ADDENDUM NO. 03

August 14, 2026

Oak Hill United School Corporation – Multi-School MEP Improvements
405 South Washington St, Swayzee, IN 46986
7760 Delphi Pike, Converse, IN 46919
600 Walnut St, Converse, IN 46919

Addendum Three (AD.03) to the drawings and specifications prepared by Gibraltar Design for **Mechanical Improvements Across Three Schools** for Oak Hill United School Corporation Converse, Indiana.

A-310

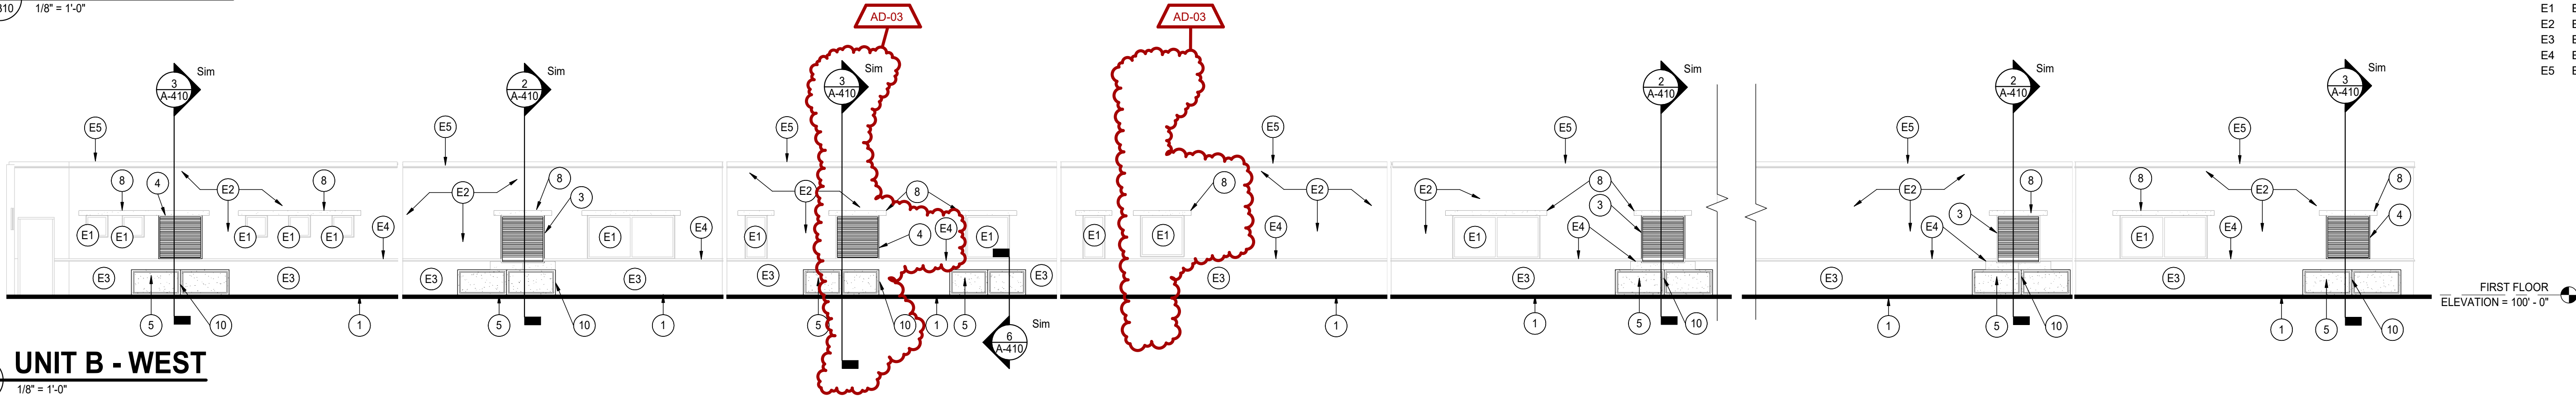
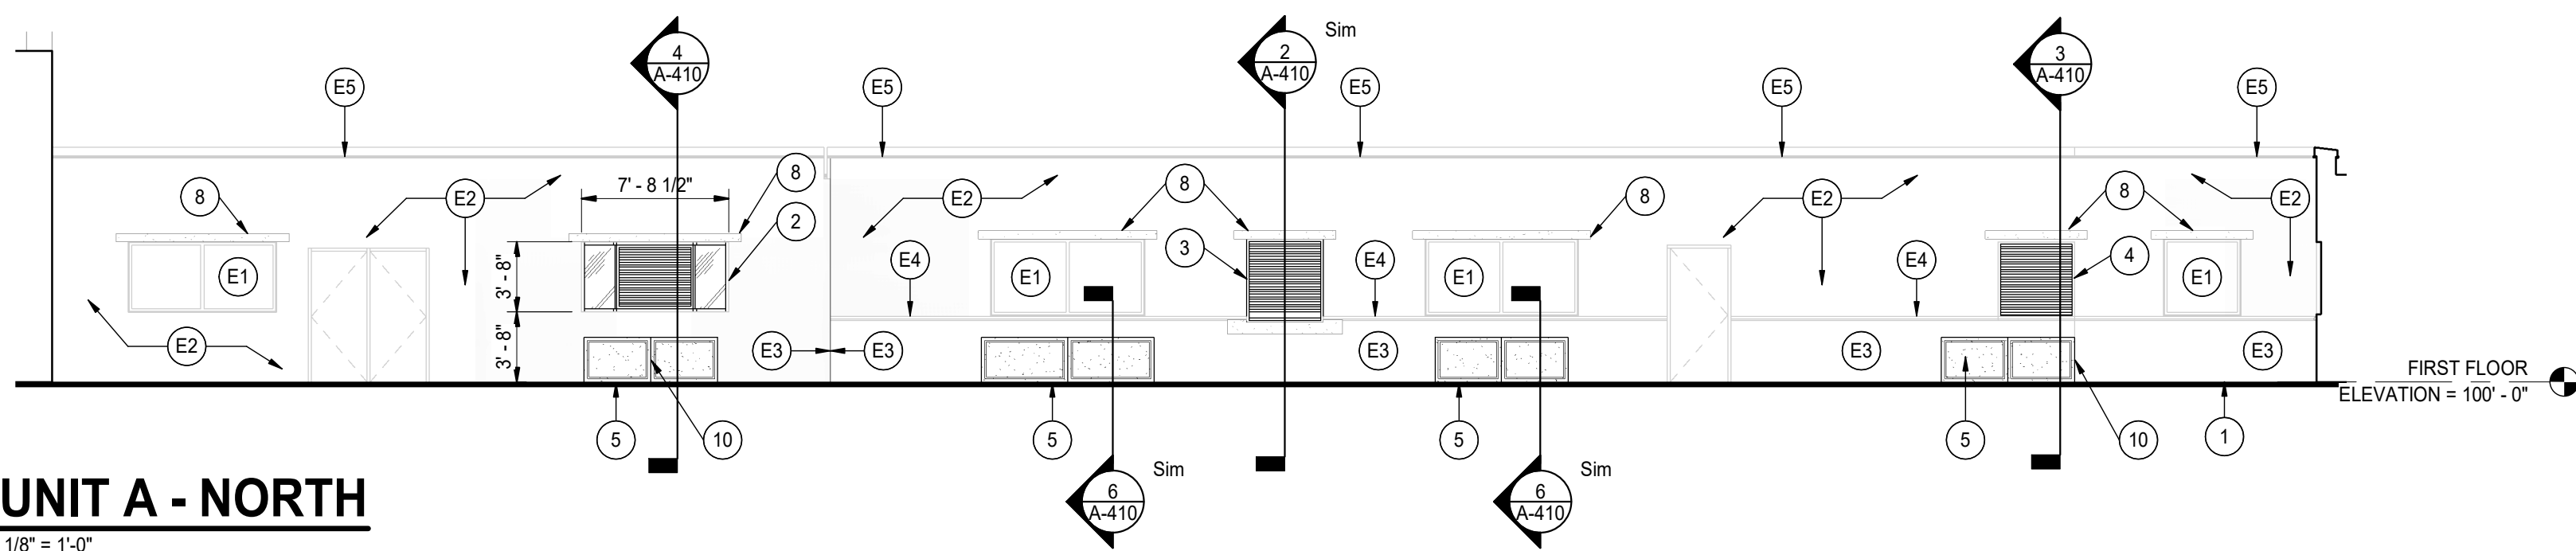
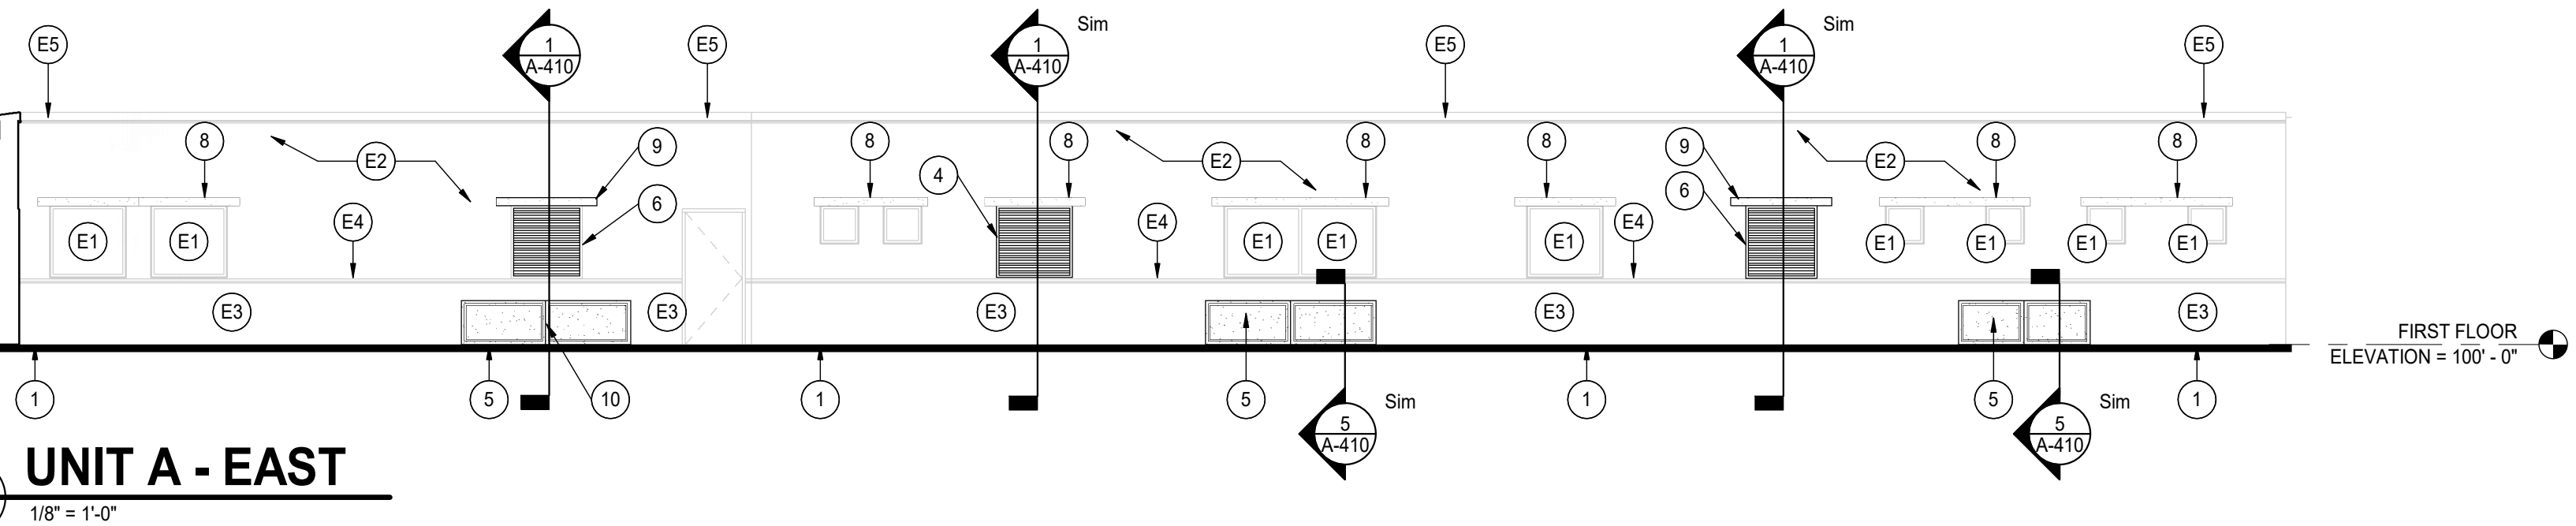
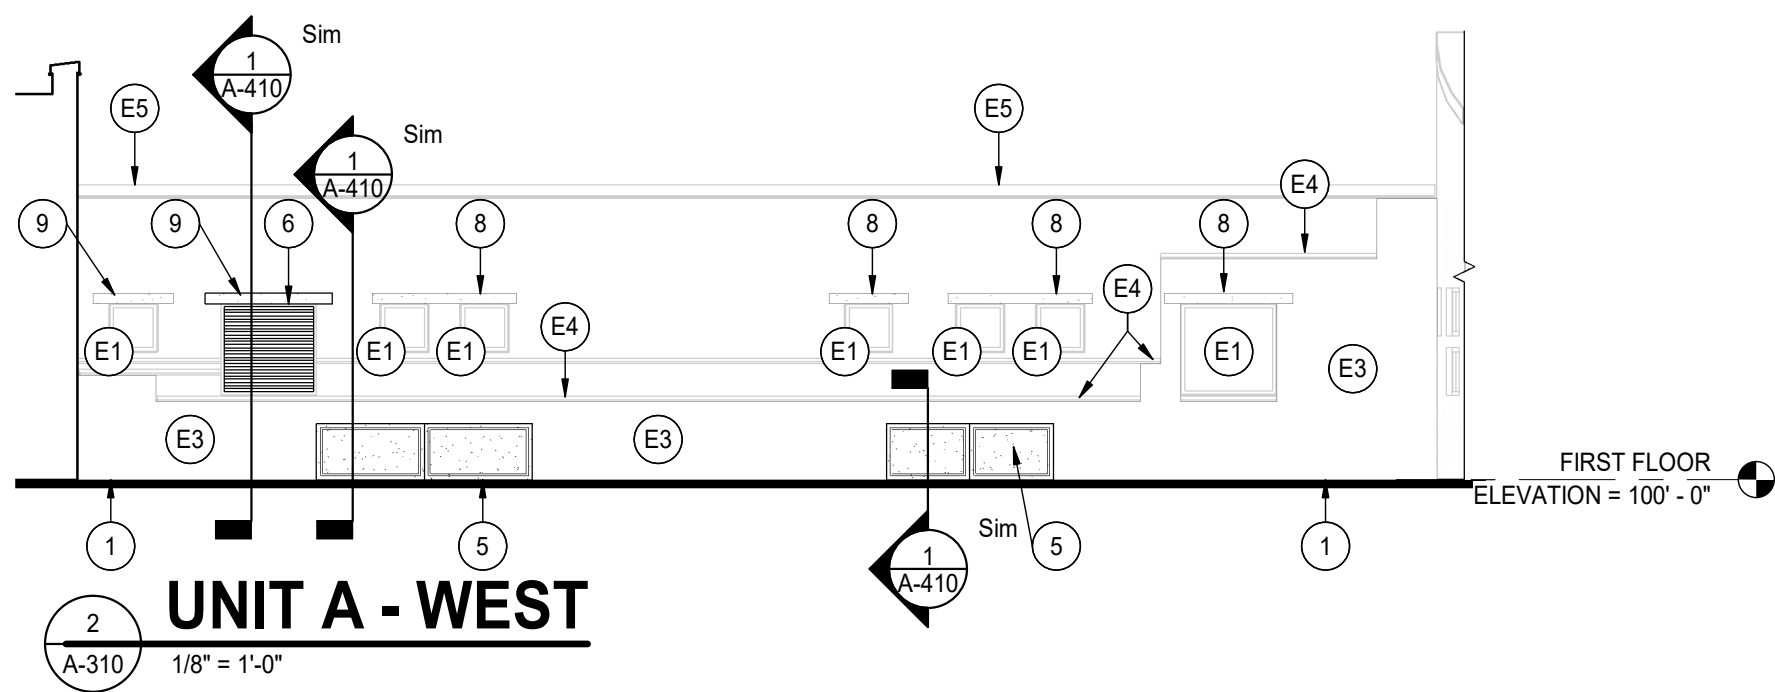
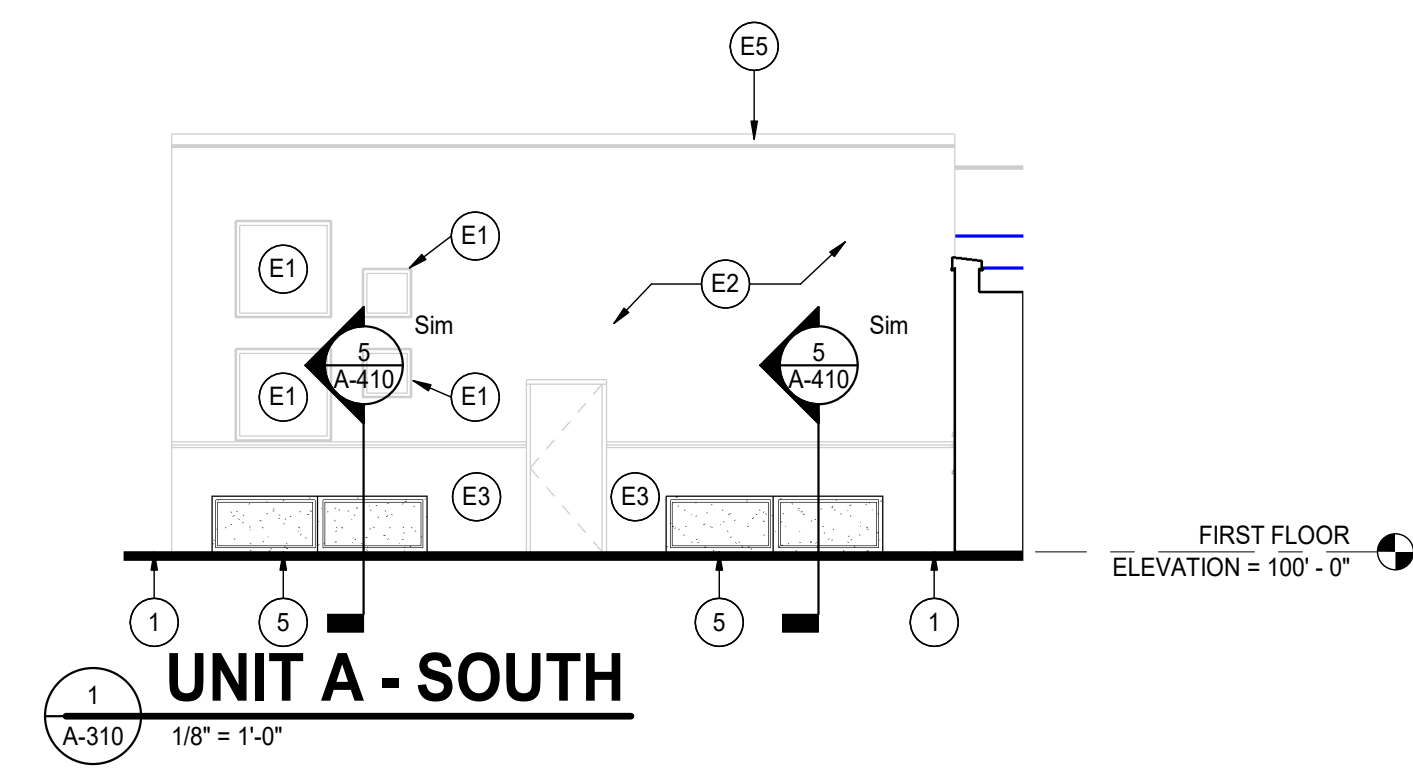
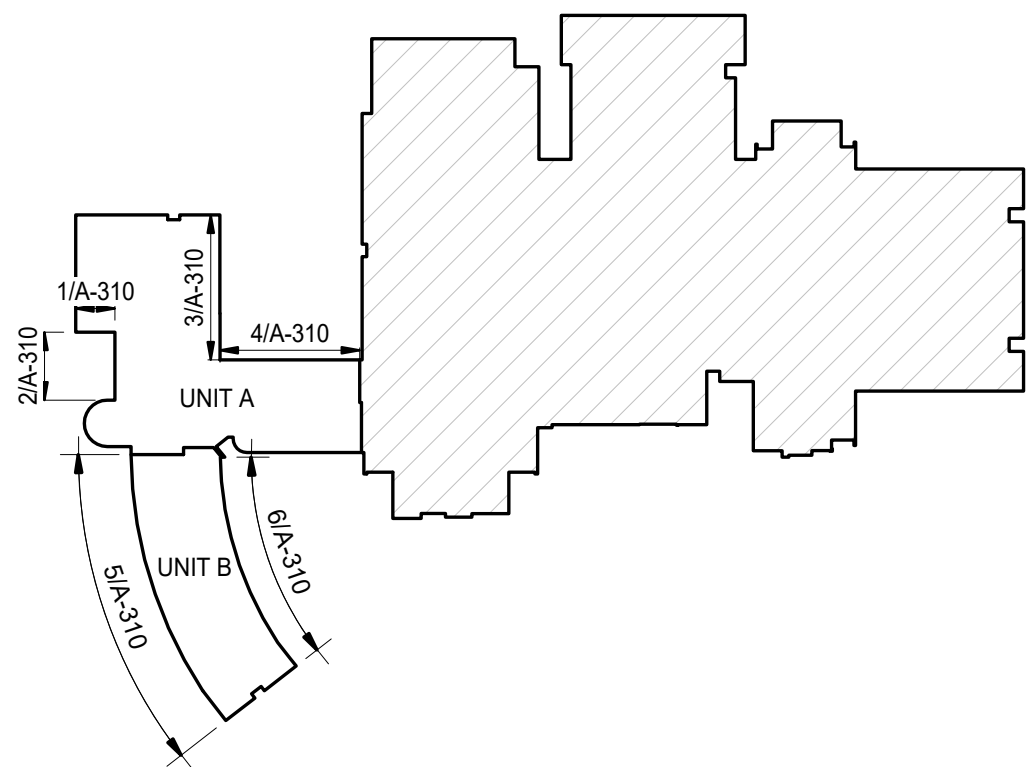
8. Sheet A-310

- A. Refer to revised, full-size drawings, included in this Addendum, for revisions.
